ADDENDUM #08

INVITATION TO BID #01

ACES at CHASE

STATE PROJECT NO. 244-0044 MAG

5 PRACTICE ROOM ELEV. A
1/2" = 1'-0"

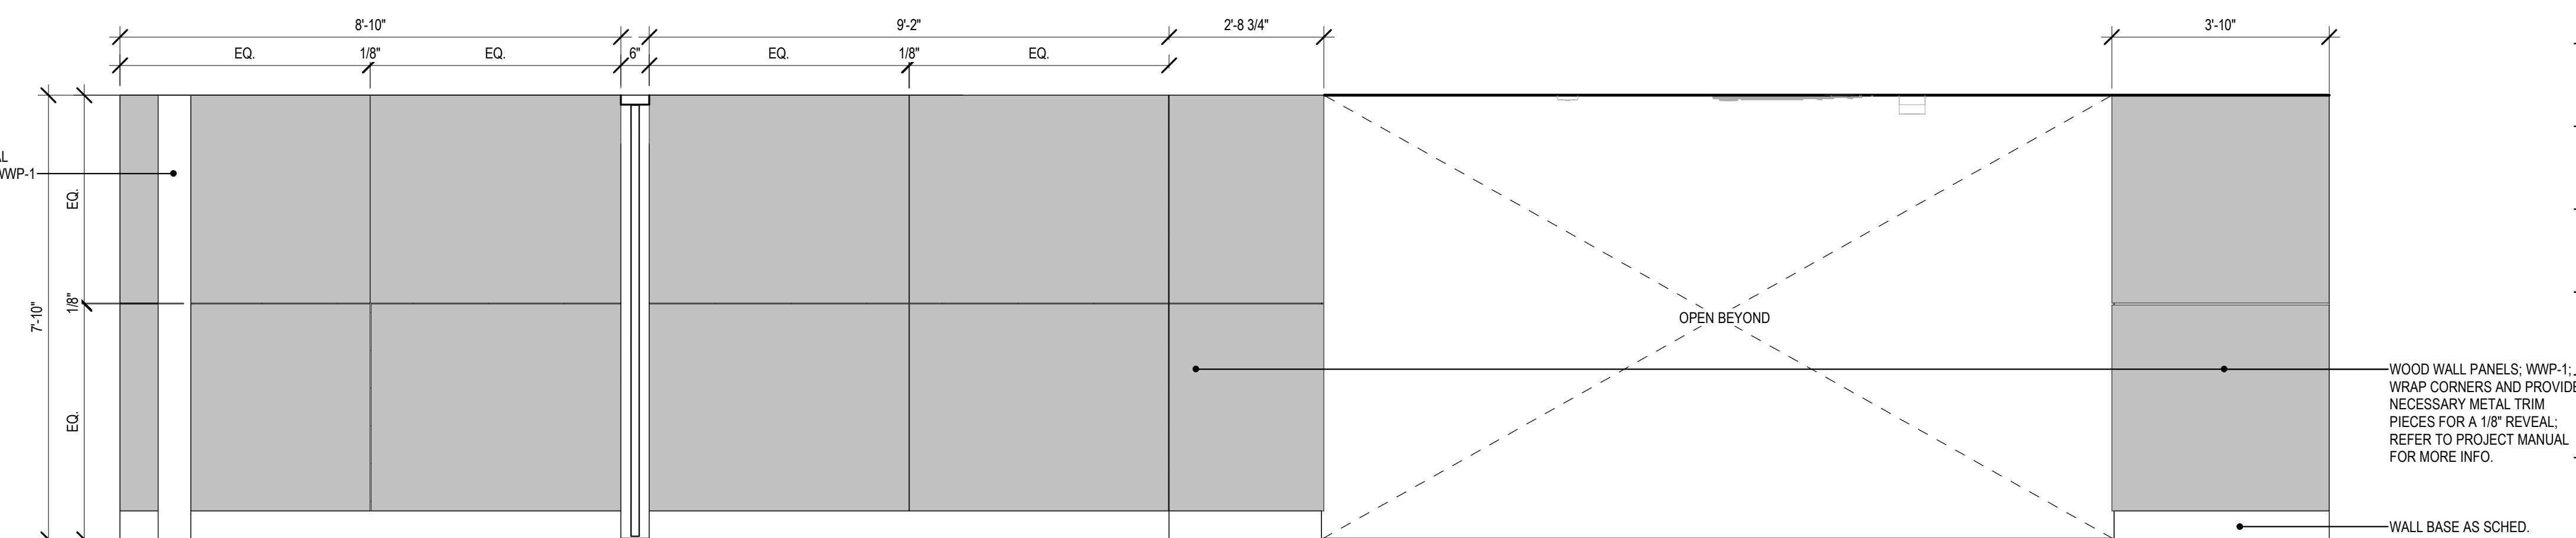
- .1. Yes. Refer to Bulletin #4 for revised Drawing A730-4.
 - .2. There are varying substrates (existing & new masonry & new gypsum board). Refer to floor plans for partition types.
 - .3. Refer to Bulletin #4 for revised Drawings A110-4 & A500-4.
 - .4. There is a wall base as scheduled. Refer to Bulletin #4 for revised Drawing A730-4.
 - .5. Refer to Bulletin #4 for revised drawings as noted above indicating WWP-1 to wrap around column.
- 1.a.ii.
- .1. Refer to Bulletin #4 for revised drawings as noted above indicating WWP-1 to wrap around column.
 - .2. Refer to Bulletin #4 for revised drawings as noted above indicating WWP-1.
 - .3. Yes.
 - .4. Refer to Bulletin #4 for revised Drawing A730-4.
 - .5. There is a wall base as scheduled. Refer to Bulletin #4 for revised Drawing A730-4.
- S/P+A-KD
